3-7 River Terrace – Design Review Panel Integration (DA24/0196)

Panel 01

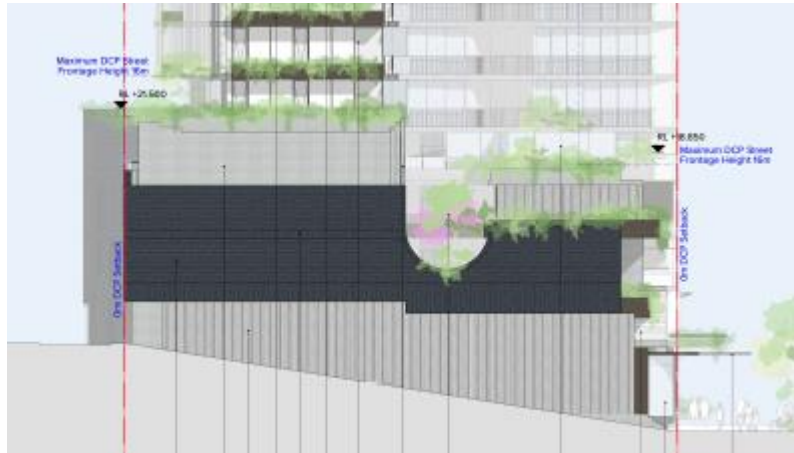
3	<p>Understand opportunities for improved public domain and landscape across the broader precinct and how the proposed development site might set up and leverage off those opportunities. While it is acknowledged that the detail design of civic spaces beyond the development sites curtilage is unlikely to form part of a future development application, design consideration of broader public domain improvements (footpath design, parking, street trees, crossing points, pavement materials, lighting, street furniture, shade structures) will be key to setting the public domain and landscape character of the precinct into the future.</p>	<p>Generally satisfied in the context of the proposed DA.</p> <p>Designing the surrounding public domain is beyond the scope of the subject site and proposed development application. However as described above, the combination of through block connection, ground floor land use and edge treatment to the two street frontages provides good opportunity for the proposal to activate and engage with the street.</p> <p>The landscape drawing package provides detail of the ground level setout, landscape areas and material palette which is considered to draw on local character elements and is appropriately robust for the envisaged use and climatic and marine context.</p> <p>Of note the landscape ground floor plan does allude to the extension of the material palette off site into the surrounding footpath, road reserve and public domain areas. These are however appropriately noted that off site works would be the subject of a future s138 application with materials and setout to be undertaken in coordination with Council.</p>

Proposed street awning to River Terrace.

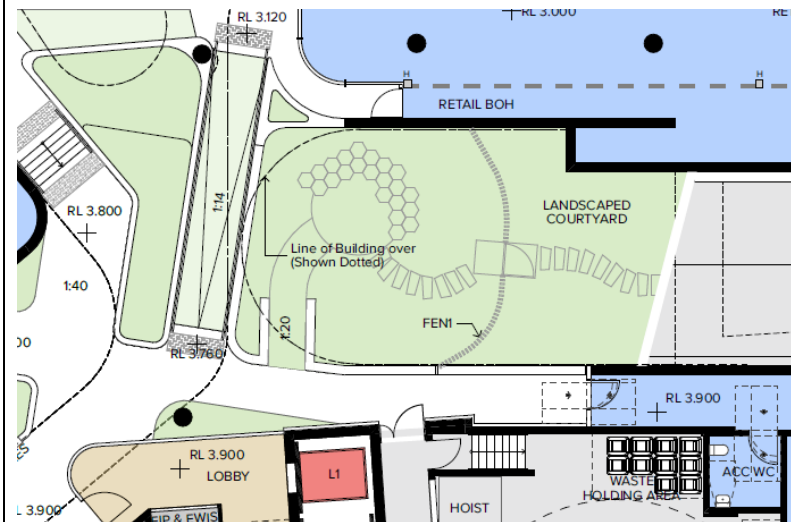
24	Preference to include awnings over the street and public domain areas for shade and weather protection but support opportunities for the awning form to reflect the intent of the public domain.	<p>Generally satisfied.</p> <p>Street awnings have been provided to the Wharf Street and River Terrace Street frontages. The form of the awning to River Terrace draws influence from the curved 'bays' of the Tweed River.</p>

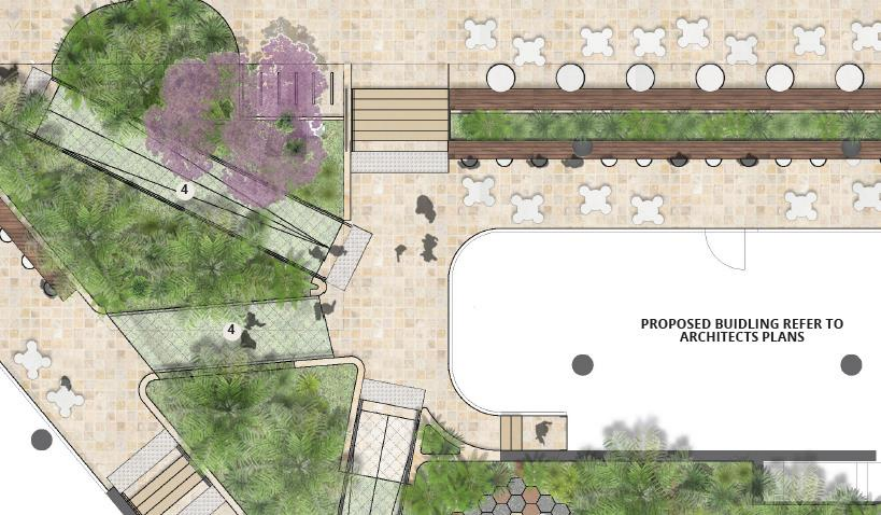
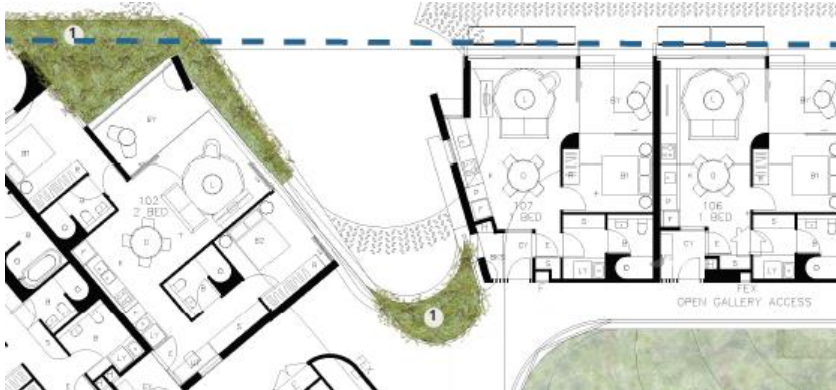
34	<p>As previously advised, there is opportunity to step beyond the site boundaries to further understand the public domain and landscape opportunities within the broader Boat Harbour Precinct. This includes pedestrian pathway connectivity along</p>	<p>Generally satisfied.</p> <p>Refer to commentary at line-items 1,2 and 3 above. While detailed design of surrounding public domain areas is beyond the scope of the subject development</p>

the site's street interfaces and desire line connections to the water's edge, potential for future event activation along River Terrace, connection to a bus stop / light rail stop along Wharf Street, on street parking, street trees and landscape opportunities within the road reserve. As the first major development site within this precinct, there is opportunity to establish a public domain material palette which would set the character for future embellishments. Council's Parks and Active Communities Team is willing to discuss these broader public domain and landscape opportunities.

application, submitted site plans, landscape plans and photomontages do provide context and visualise some opportunities within the road reserve.
